MODIFICATION REQUEST:

Concept Plan for Residential Development

**5 Whiteside Street and 14 and 16 David Avenue,
North Ryde**

Secretary's Environmental Assessment Report
Section 75W of the
Environmental Planning and Assessment Act 1979

Figure 2: Extent of proposed building envelopes and approved building envelopes (red dotted line) and indicative first floor apartment layout (Source: proponent's application)

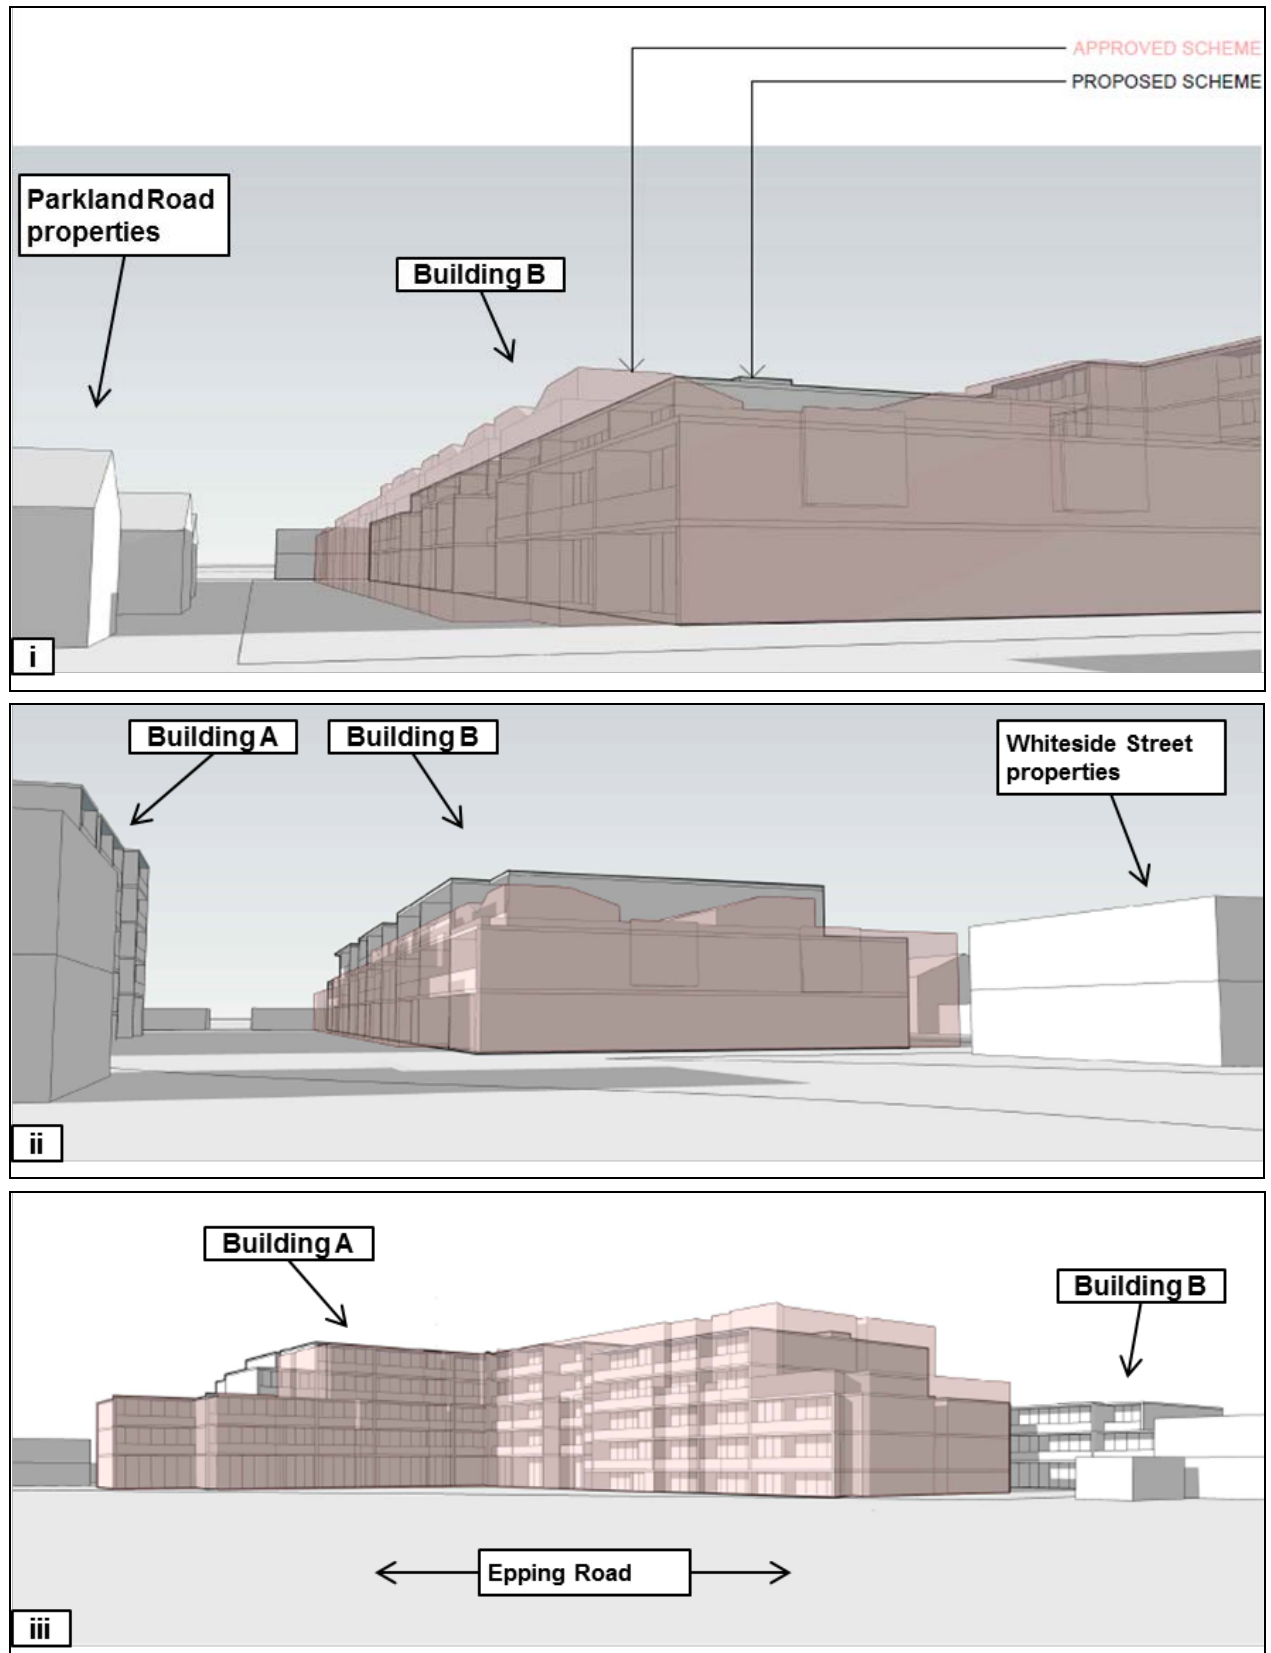
Comparison images of the approved and proposed modified concept plan are shown at **Figures 2 and 3**. Further details of the proposed modifications are provided at **Appendix A**.

Figure 4: Approved envelope heights, Building A as revised by the PAC (Source: MP10_0165 Condition B1)

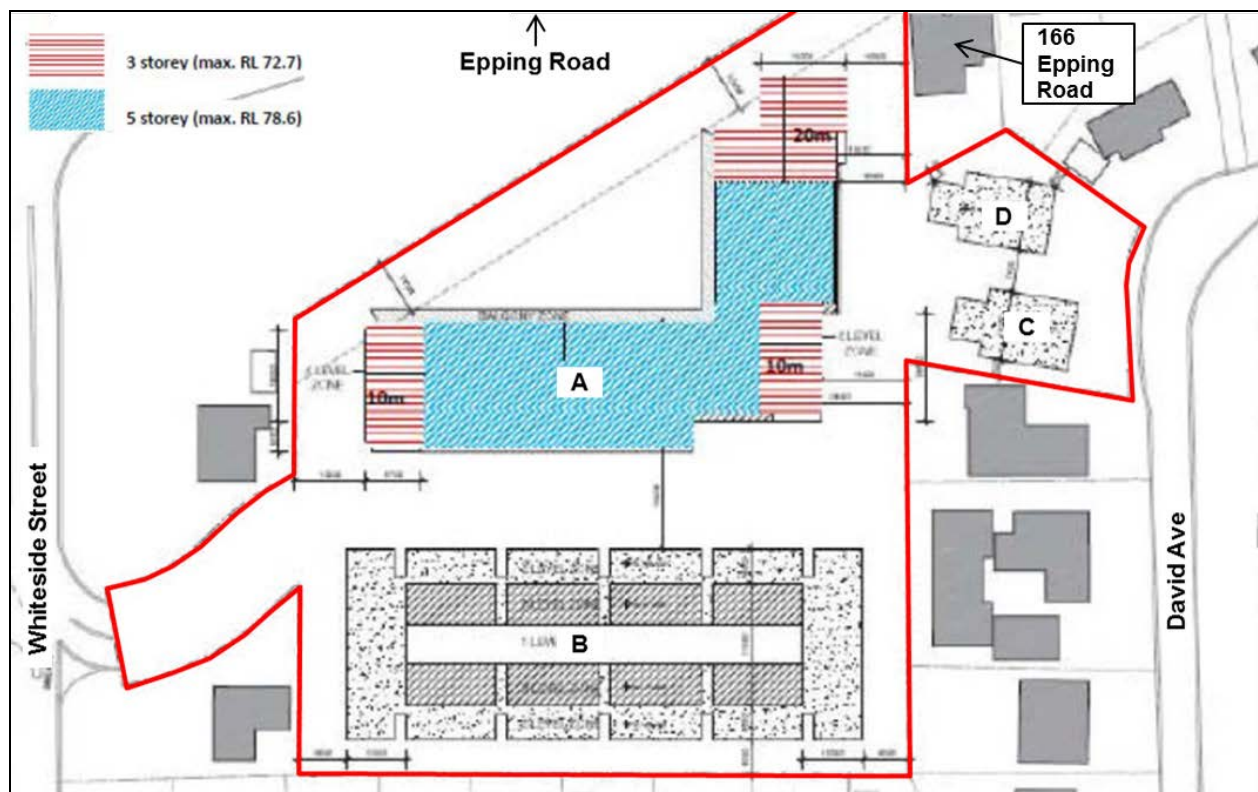
The PAC, however, was of the view that a six storey building in this location was excessive. To improve the transition to the surrounding area the PAC reduced the height of Building A to part three, part five storeys (refer to **Figure 4**).

Figure 5: Proposed third and fourth floor of building envelope A, indicative apartment layouts and western elevation. The extent of approved building envelope is shown by dotted red line (Source: proponent's application)

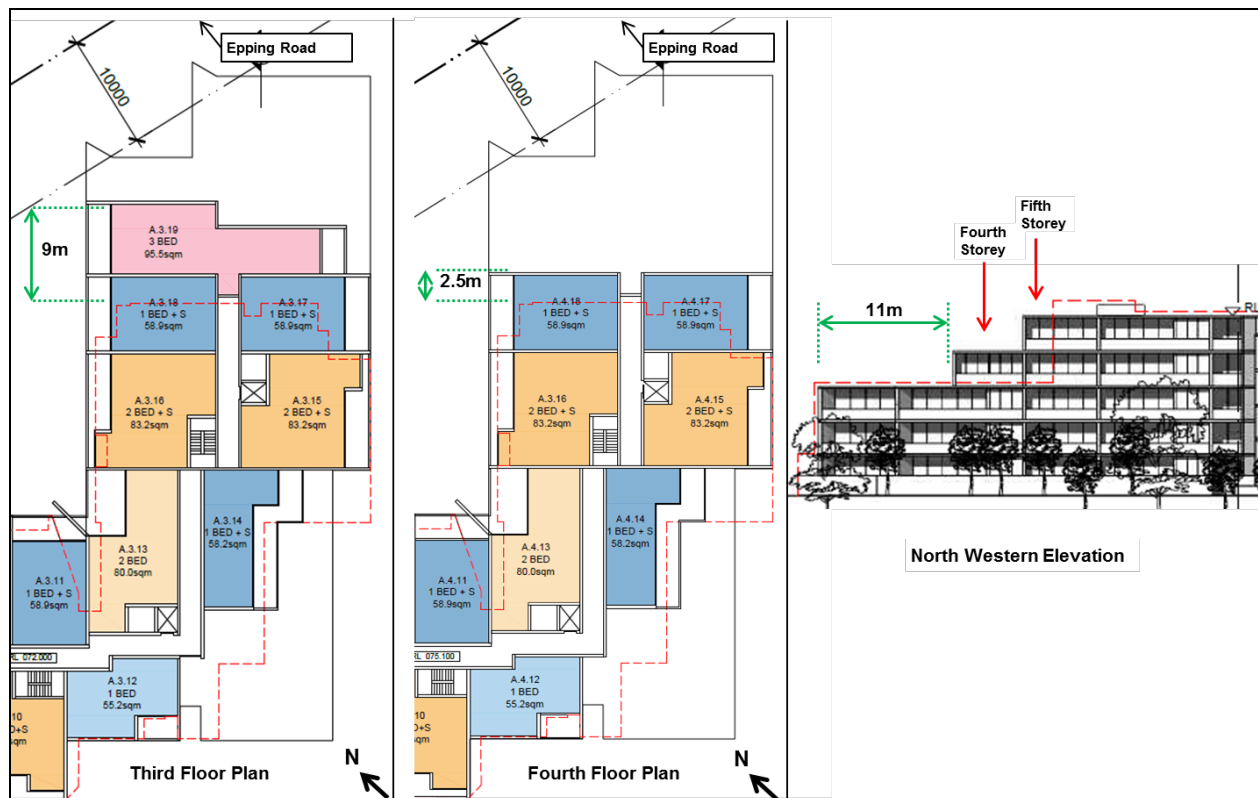
As approved the north east wing of building envelope A is three and five storeys. The proposal seeks an expansion of the building envelope in this location, providing for an additional step in building height at the fourth storey and minor enlargement at the fifth storey (refer to **Figure 5**). The proposal also seeks minor reductions in the height of the north west wing of the building envelope as shown at **Figure 3(iii)** and other minor expansions and reductions of the building envelope depth.

The Department is of the view that the proposed amendments to building envelope A are acceptable, as:

- the additional fourth storey element of the north east wing is setback 11 metres from the three storey building element below and maintains an appropriate transition of built form to the neighbouring low rise buildings;
- the fourth storey element would be located 20 metres from Building D and 17 metres (obliquely) from 166 Epping Road and is therefore consistent with the RFDC recommended 12 metre minimum building separation requirements for buildings up to four storeys;
- the amendments would not result in an increase in the overall height of the building envelope;

Figure 6: The distance of the approved (blue) and proposed (green) first floor building envelope from the rear of the neighbouring Parkland Road properties. The extent of approved building envelope is shown by dotted red line (Source: proponent's additional information)

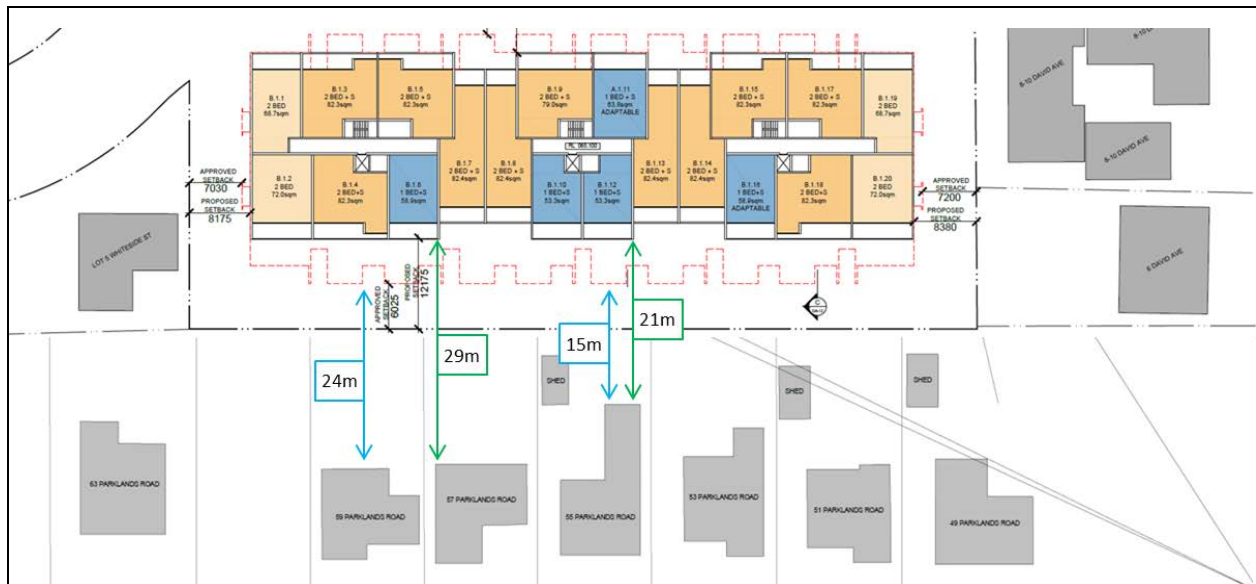
The Department notes that the application proposes to significantly reduce the depth of building envelope B. As a consequence, it is approximately six metres further away (a total of 21 metres) from the closest rear elevation of the neighbouring residential buildings fronting Parklands Road (refer to **Figure 6**).

As approved, the rear elevation of building envelope B is located between 15 and 24 metres from the rear elevations of properties fronting Parklands Road and six metres from their rear boundaries (refer to **Figure 6**).

The Department is of the view that the reduction of the building envelope depth and consequential increase in the distance between the rear boundary and the rear elevations of properties fronting Parklands Street (an additional six metres), reduces the visual and amenity impacts of the building on the Parklands Street properties. Furthermore, substantial deep soil planting including screening planting will be provided along the boundary. On this basis privacy may be maintained between properties and therefore there is no justification for the prohibition of balconies.

Figure 7: Proposed top floor (level 2) building envelope and the indicative apartment layout. The extent of approved building envelope is shown by dotted red line (Source: proponent's application)

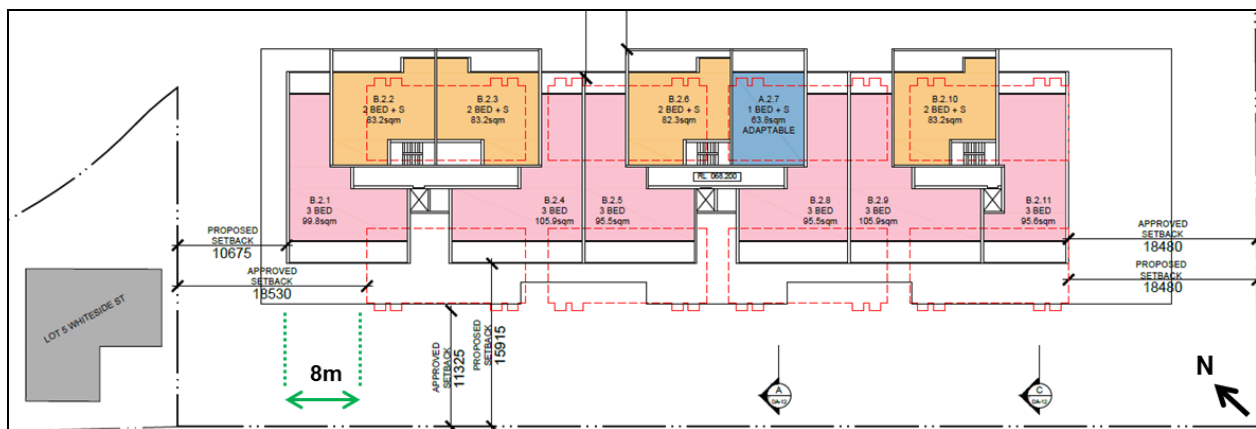
As approved, building envelope B is three storeys high. The ground and first level are 33 metres deep and setback six metres from the rear boundary of properties fronting Parklands Road to the south (refer to **Figure 2 and 6**). The uppermost floor (level 2) includes a six metre setback from the level below (front and back) and comprises eight separate pop-up roof extensions (refer to **Figure 7**). The proposal seeks to amend the envelope by:

The amendments to building envelope B, including the expansion of uppermost floor, are acceptable as:

- the reduction in building envelope depth results in an increased setback from neighbouring dwellings (minimum 21 metres), which will reduce the building's perceived scale and bulk when viewed from the Parklands Road properties;
- the uppermost floor will be setback 2.5m from the western edge of the building and 12 metres from the rear of 5 Whiteside Street and is therefore consistent with the RFDC recommended 12 metre minimum building separation requirements. The Department further recommends a FEAR to prevent balconies in this location to ensure privacy is maintained;
- as discussed at **Section 5.5**, the proposal would not result in any adverse overlooking;
